File Number:	Roll Number:
Location of Property: <i>Douro 7th Line</i>	
Owner (s) Name: <i>Bandy Moloney</i>	
Phone Number: <i>705-748-9399 705-760-0163</i>

Roll # 1522-010-003-12601

Lot 11, Concession 7, Douro

Lot B

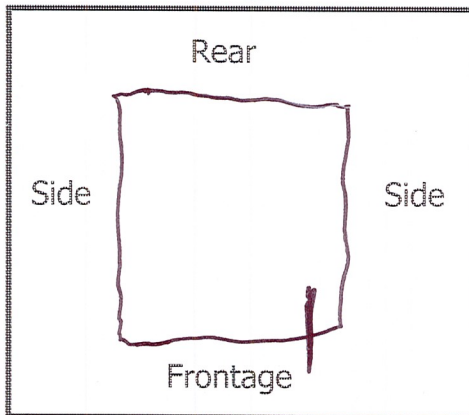
Street/Road Name:	<i>Douro 7th Line</i>	
Safe Entrance Possible:	Yes ☒	No ☐
Culvert Required when lot developed:	Yes ☐	No ☐
3 metre strip of frontage from severed parcel required:	Yes ☒	No ☐
Other Requirements (i.e. fill, brushing, etc.): <i>brushing side lines & minor ditching to achieve drainage</i>

Retained (if vacant)

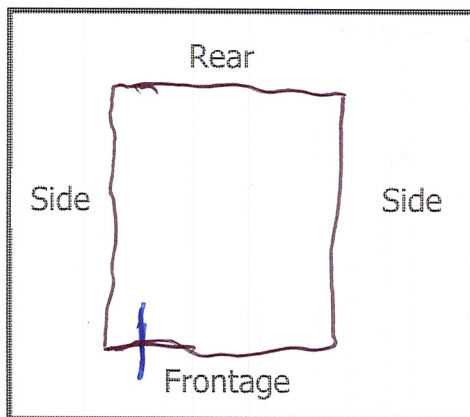
Street/Road Name:	<i>Douro 7th Line</i>	
Safe Entrance Possible:	Yes ☒	No ☐
Culvert Required when lot developed:	Yes ☐	No ☒
3 metre strip of frontage from severed parcel required:	Yes ☐	No ☒
Other Requirements (i.e. fill, brushing, etc.):

Additional Comments: *Minor brushing to achieve safe site lines*
Minor ditching for drainage - 6% gradient to roadway when completed.
